RE: CDP\_2023-0009 Response to Coastal Commission Commentary dated 3/15/24

Site: 33389 Pacific Way  
Fort Bragg, CA 95437  
APN: 017-320-51-00

RE: Alternatives Analysis for CDP #2023-0009 – response to CCC Commentary  
33389 Pacific Way  
Fort Bragg CA 95437  
APN: 017-320-51

Figure 2. Alternative A development relative to presumed ESHAs.

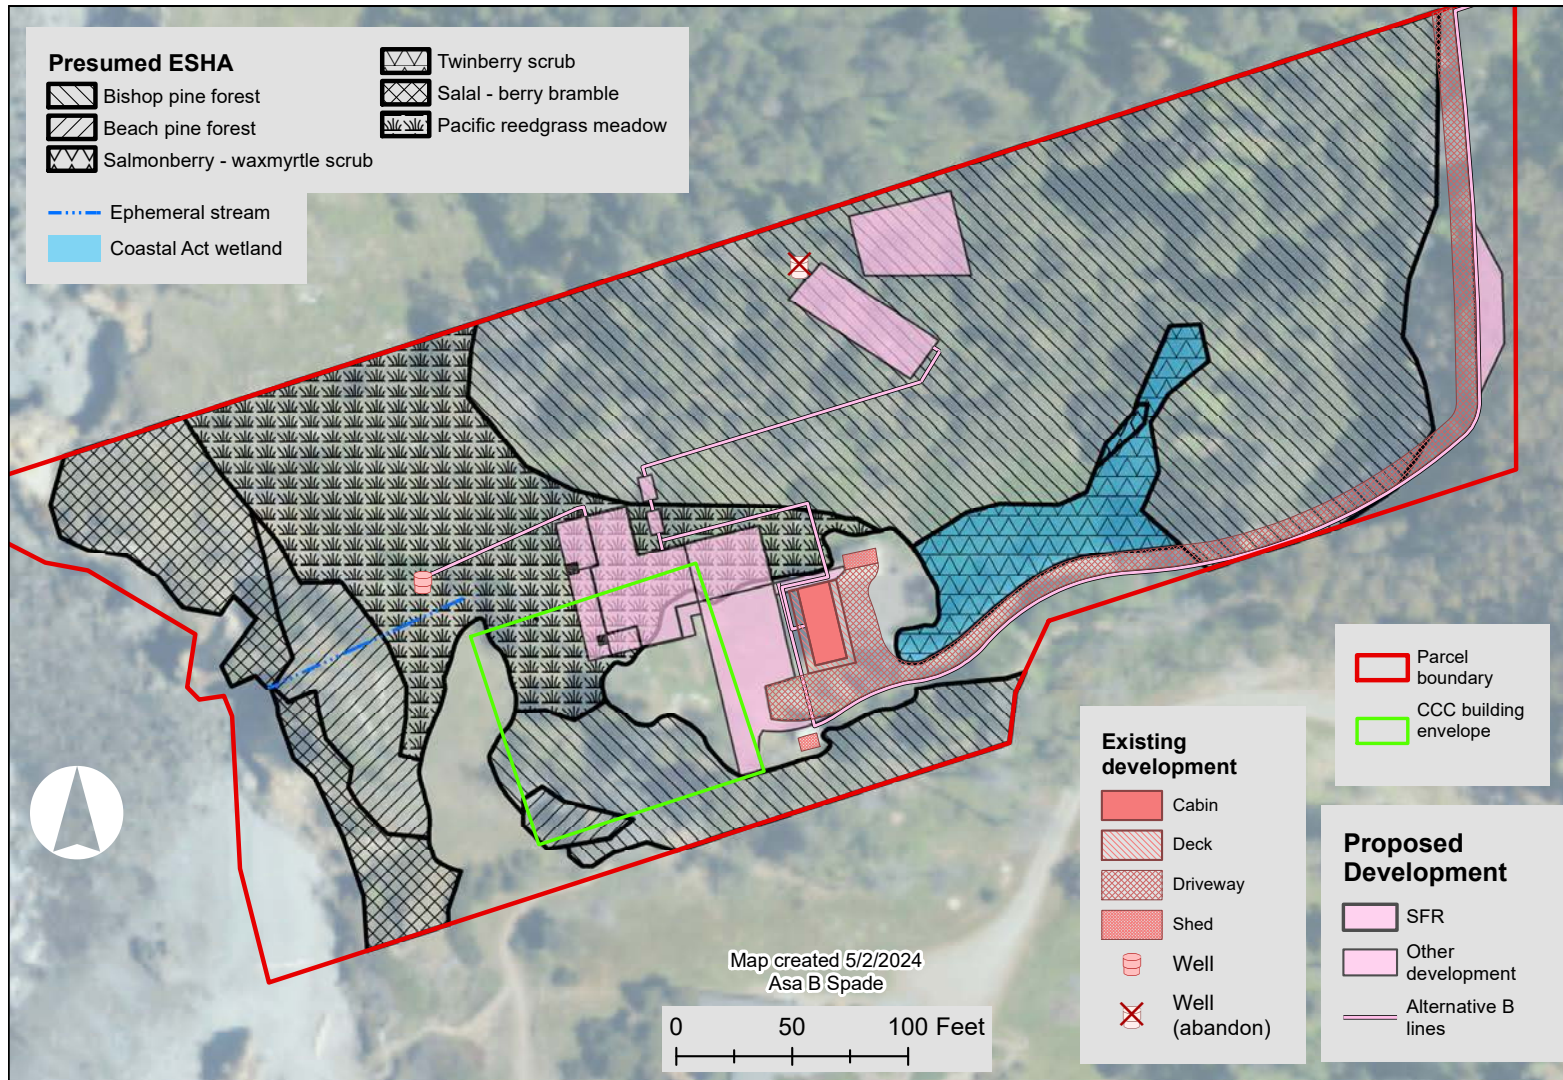
Alternative A is similar to the proposed project in most ways, with all structures within the CCC building envelope but the structures are placed approximately 12ft further south and 5ft east as compared to the proposed project. This maximizes distance between the structures and the ephemeral stream while maintaining the angle at which the structures were designed. This configuration also reduces direct impact to Pacific reedgrass meadow but pushes the structure further into Bishop pine forest. Alternative A is the best design for minimizing development within the 50ft buffers to wetlands and the stream but has more direct impact to special status plant communities than the proposed project.

Figure 3. Alternative B development relative to presumed ESHA.

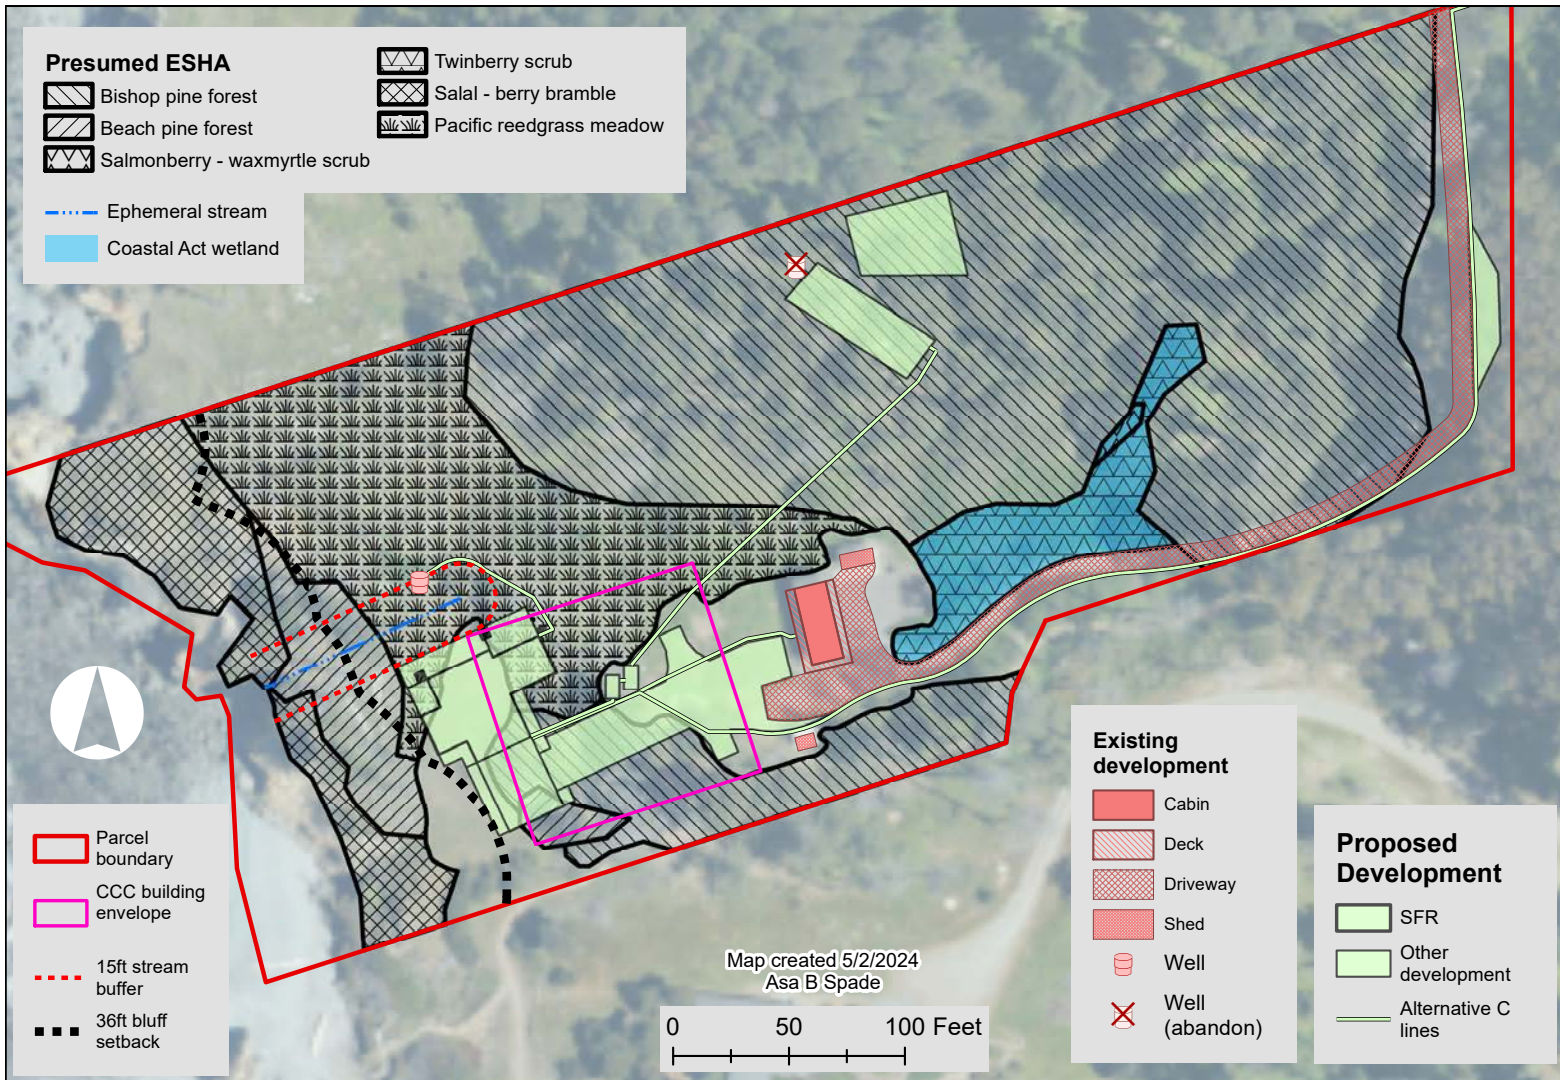
This alternative configuration would locate the SFR further north than the proposed project, outside of the CCC building envelope, which allows the approach to the garage to be more direct rather than looping around to the northern side of the garage. This configuration also maximizes the distance of development from the ephemeral stream and Coastal Act wetland presumed ESHAs by roughly centering the development between them. This configuration has the second least area of development within 50ft wetland and stream buffers, being roughly comparable to Alternative A. This alternative has the least amount of development within 50 and 100ft buffers around upland plant communities but has more direct impact to these communities than both Alternative C and the proposed development.

Figure 4. Alternative C development relative to presumed ESHA.

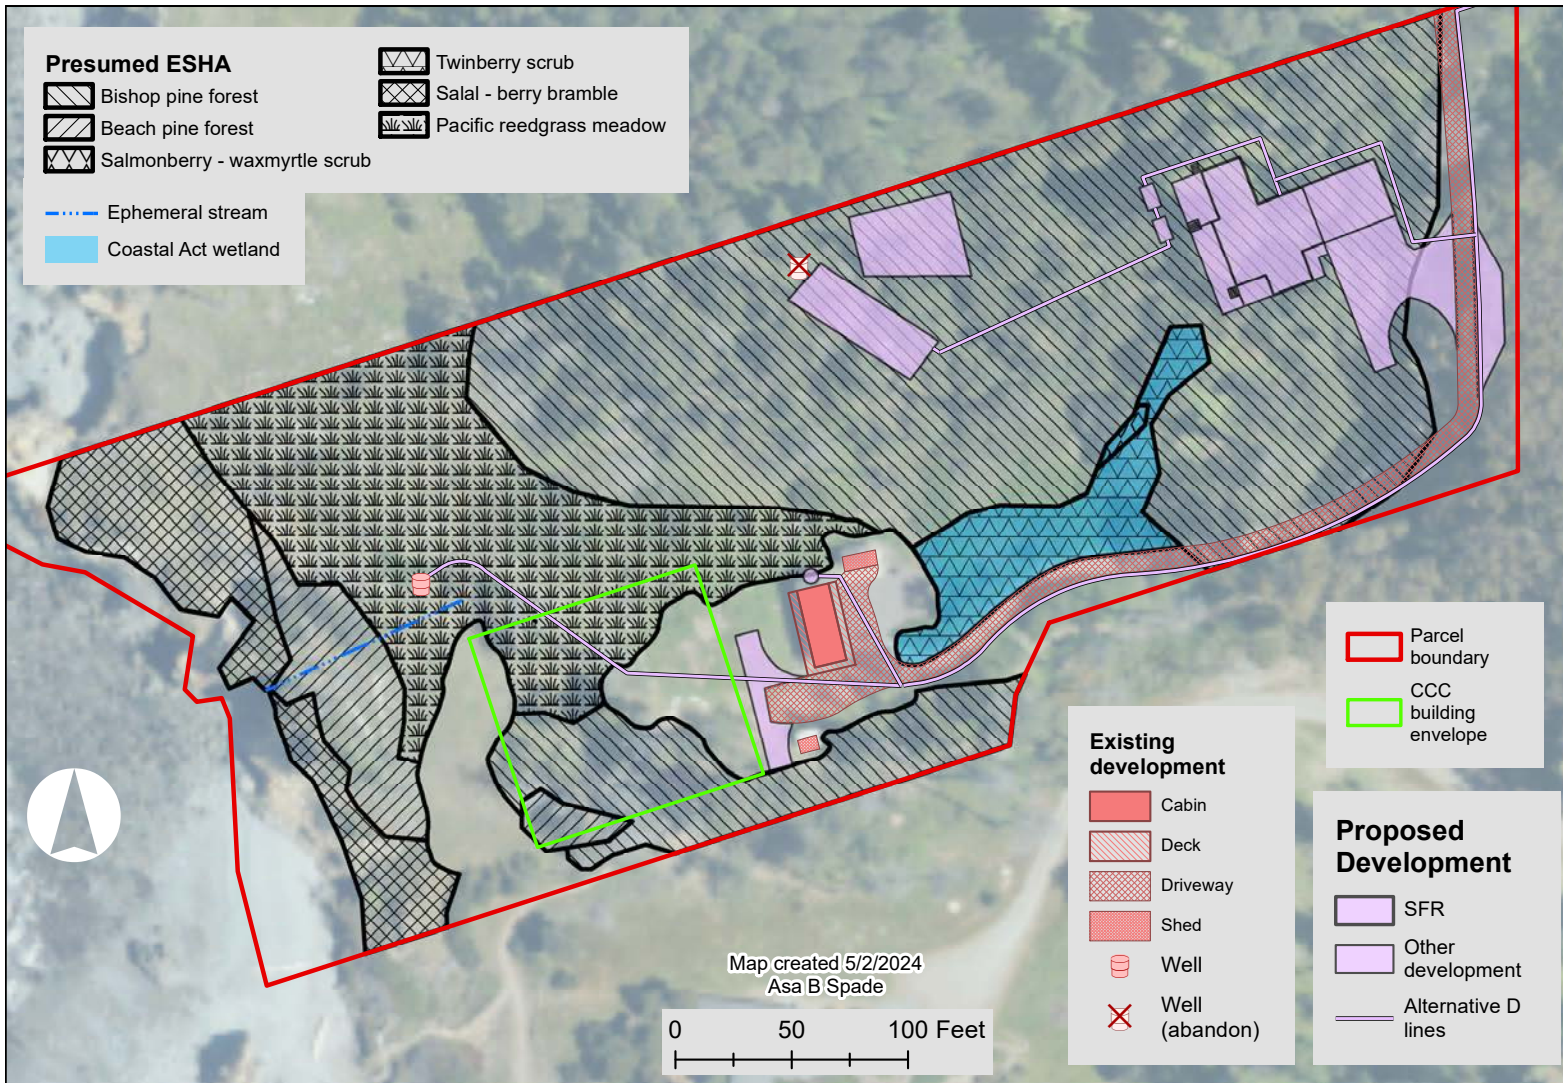
This alternative was an attempt to locate the development further west than the proposed development, outside of the CCC building envelope, in an area where non-native grassland is dominant. This alternative complies with the 15ft setback to the ephemeral stream addressed in the subdivision process. The SFR would comply with the 36ft setback to the bluff edge specified by the geotechnical report, rather than a 50ft setback to the top of bluff that would be consistent with the discussion in the creation of the CCC building envelope placement. This configuration would allow the owners to have the best ocean views. This configuration places the SFR furthest from the Coastal Act wetland twinberry scrub and salmonberry – wax myrtle scrub communities. Alternative C has the least direct impact to upland plant communities, though it is only a slight improvement over the proposed development in this regard.

SITE PLAN | 1:30 | 1

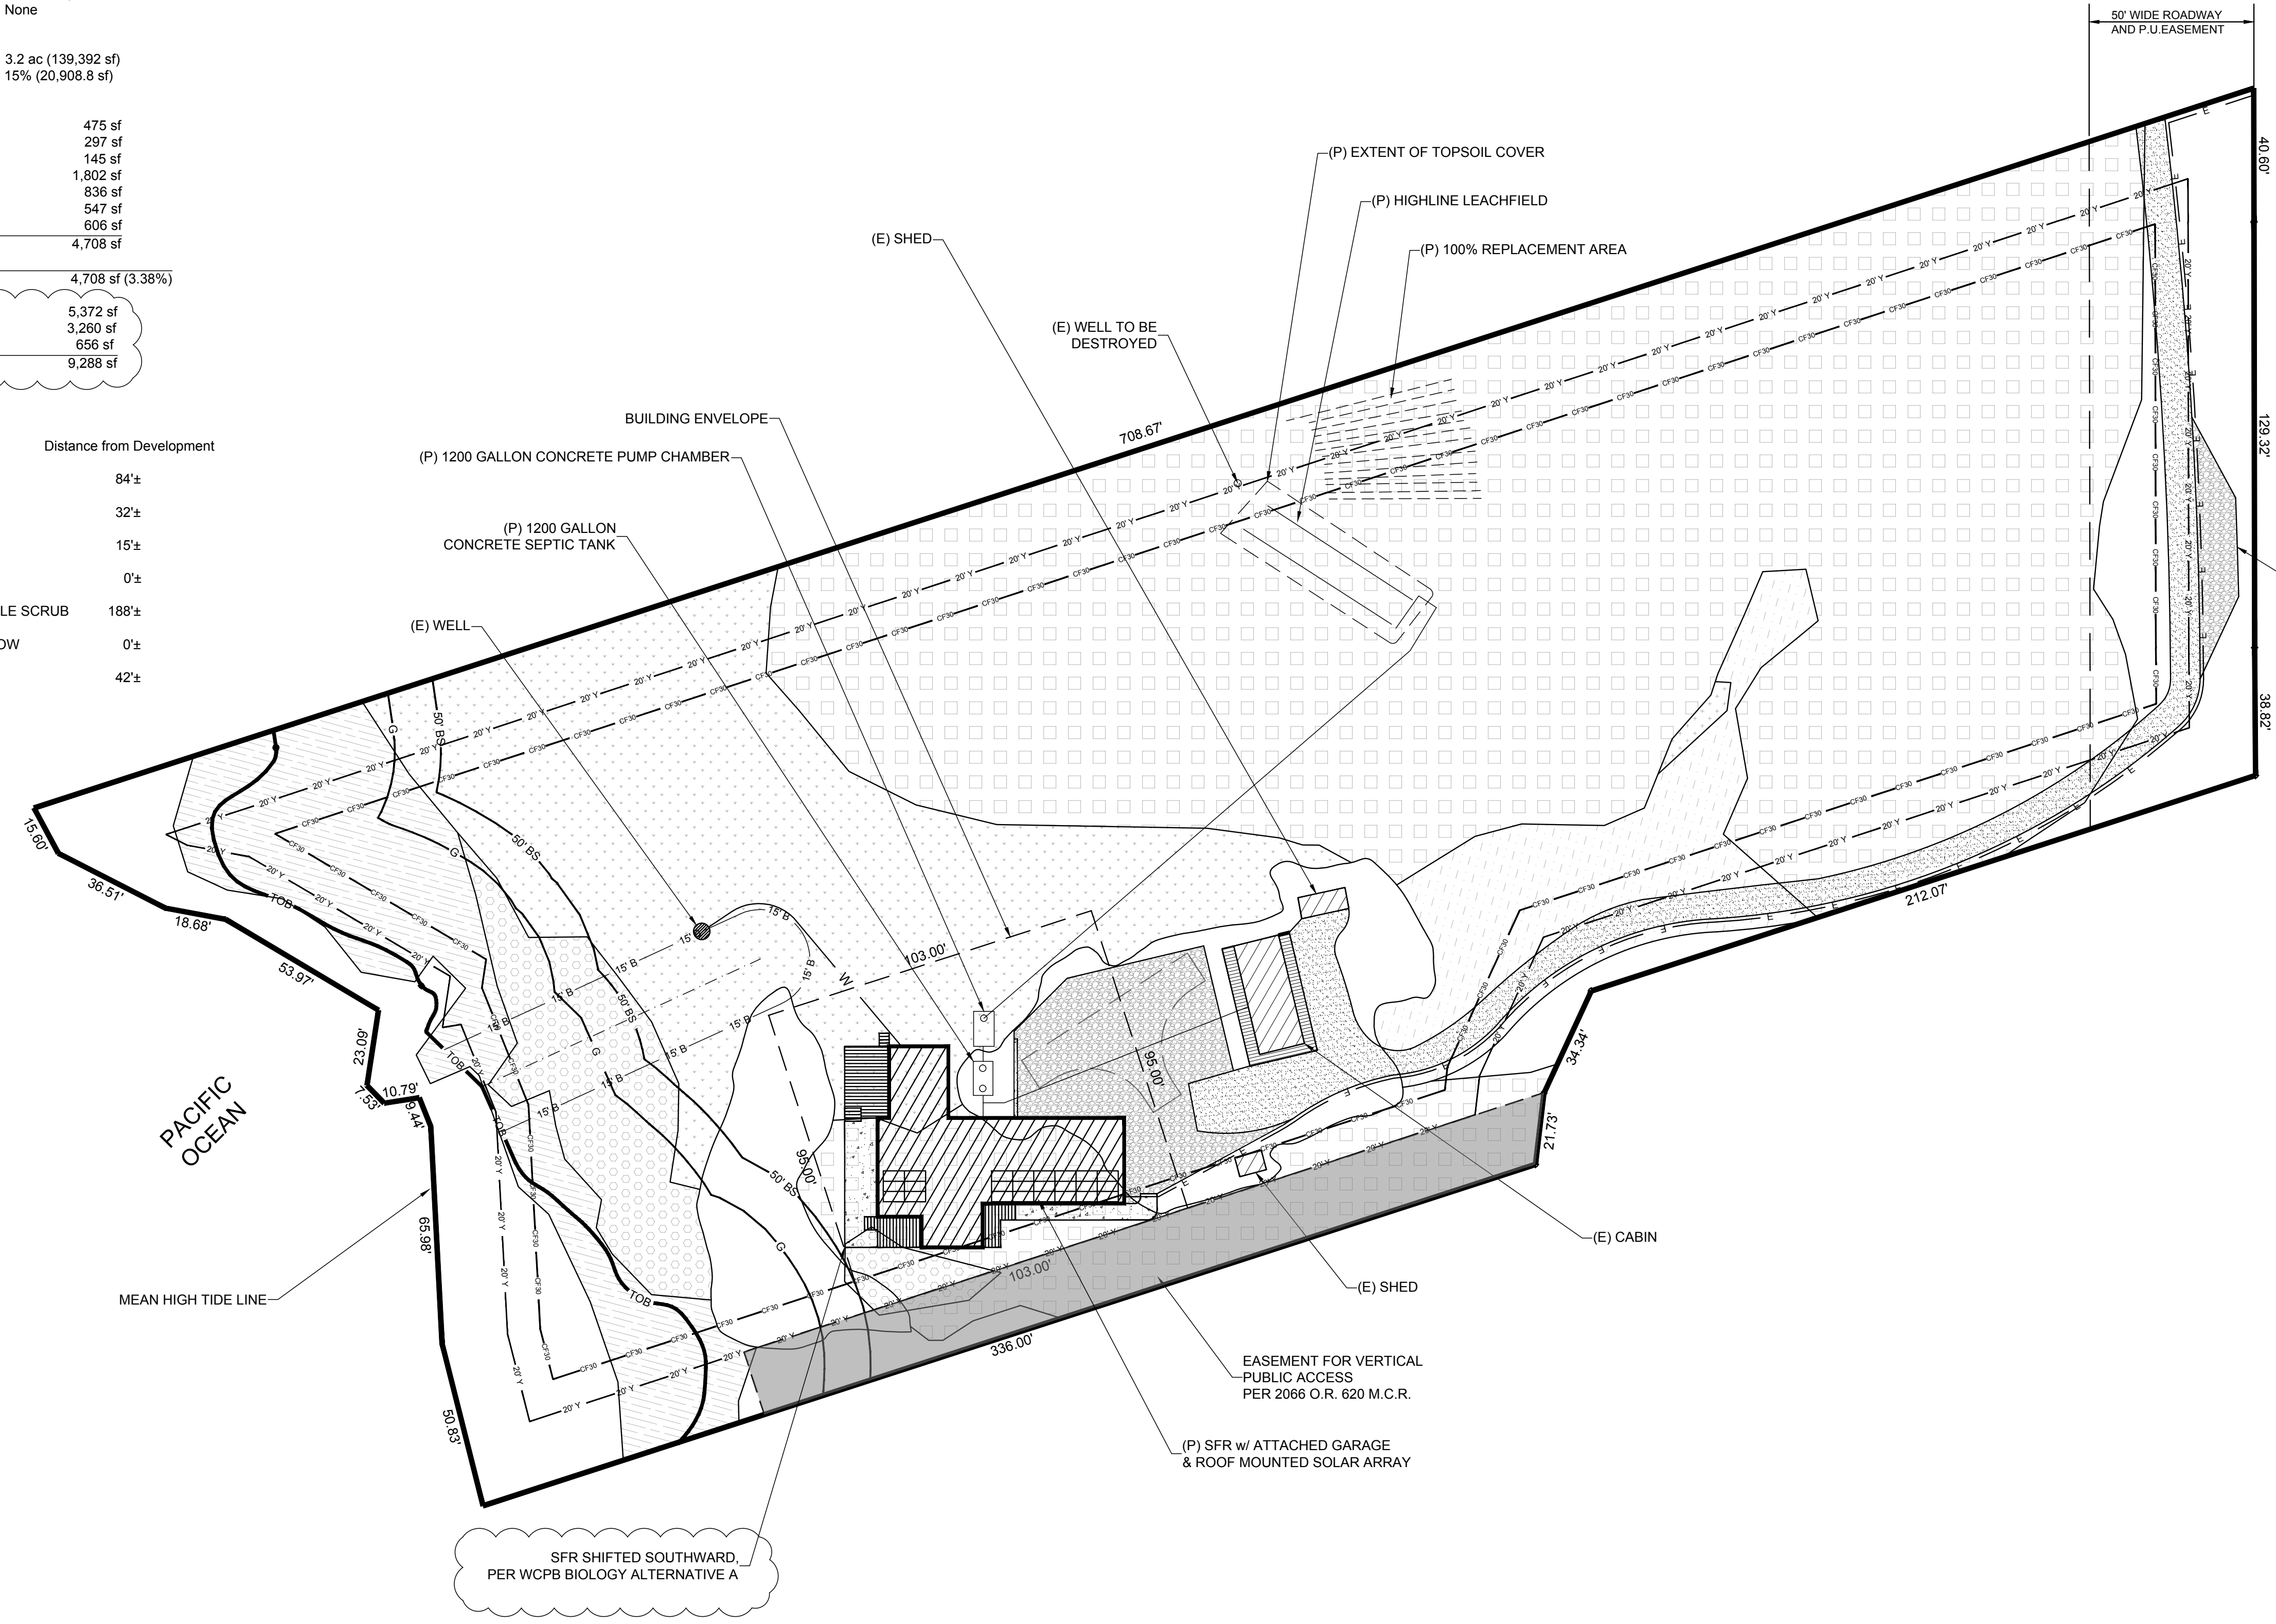
As an indirect result of creating the Alternatives Analysis, it was discovered that a turnout along the driveway, required by CalFire Fire Safe regulations, had been inadvertently left off the project site plan and biological mapping. Hence, please note the following change to the project description to include that necessary element:

Coinciding with the revision to Alternative A and the revised project description, a revised site plan is also included in this submittal illustrating the location of the CalFire turnout and the change to the development footprint as reflected in Alternative A of the Alternatives Analysis.

SFR SHIFTED SOUTHWARD  
 PER WCPB BIOLOGY ALTERNATIVE A

Construct a 1,802sf single-family residence with attached 836sf garage; 297sf of decks; roof mounted solar panels; septic system (primary and replacement); destroy one existing well and connect proposed single-family residence to western well through proposed trenching; trench to connect to PG&E; **construct turnout along driveway per CalFire requirements**; extend existing driveway and parking area by 2,942sf. Convert existing, legally non-conforming 475sf cabin to an ADU.
